Rolling Stock – Freight Wagon National Technical Specification Notice

WAG NTSN – Technical Annex

Draft for preliminary consultation based on the [NTSN published on 1st January 2021](#) with the [ERA proposals for the TSI 2022 package \(Digital Rail and Green Freight\)](#) shown as changes to this. The markup reflects the proposed TSI text, except where this has been amended for applicability to GB, such as substituting 'NTSN' for 'TSI'. Please note, this draft may still include TSI proposals which need to be further amended where text is not applicable to GB.

National Technical Specification Notice for the ‘rolling stock — wagons’ subsystem

Figure 1

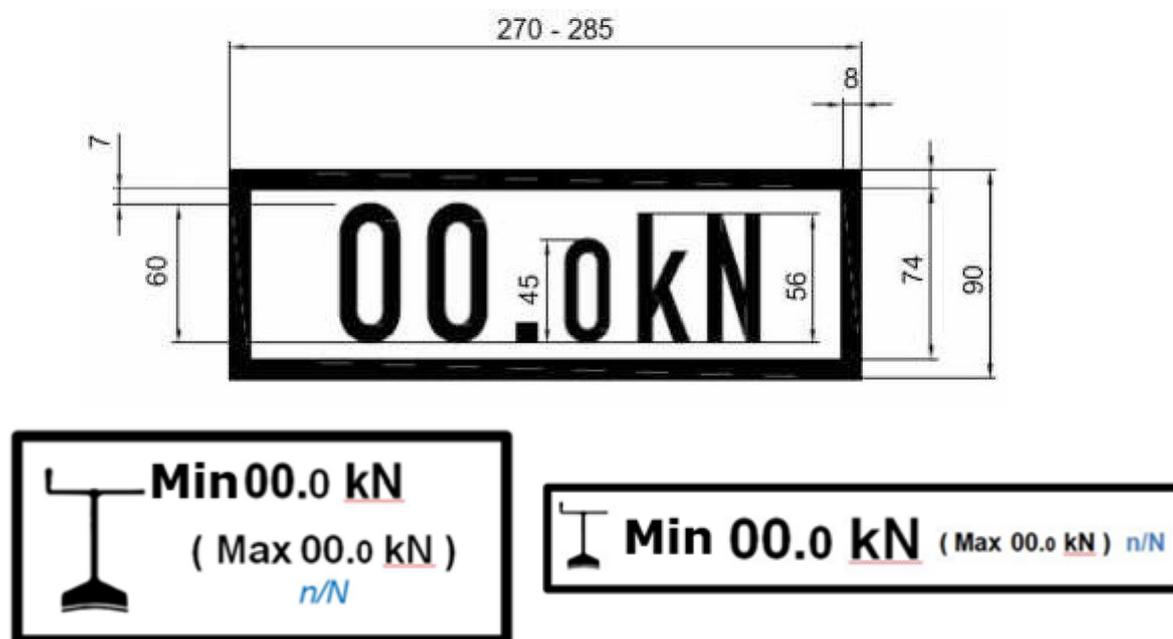
- (h) The minimum and, where relevant maximum parking brake force, the number of wheelsets (N) and the number of wheelsets, on which the parking brake is applied (n)~~The parking brake force shall be marked as set out in Figure 1, 30 mm below the marking defined in clause 4.5.3 of EN 15877-1:~~

<u>7.1.2 (h) Marking of the parking brake</u>	<u>7.1.2 (h) Marking of the parking brake</u>	<u>Change in the required marking</u>
<u>Appendix C (9)</u>	<u>Appendix C (9)</u>	<u>Evolution of the specification referenced in Appendix A, indexes [38], [39], [42], [46], [48], [49], [58]</u>
<u>Appendix H</u>	<u>New requirement</u>	<u>Inclusion of requirements on the codification of wagons</u>
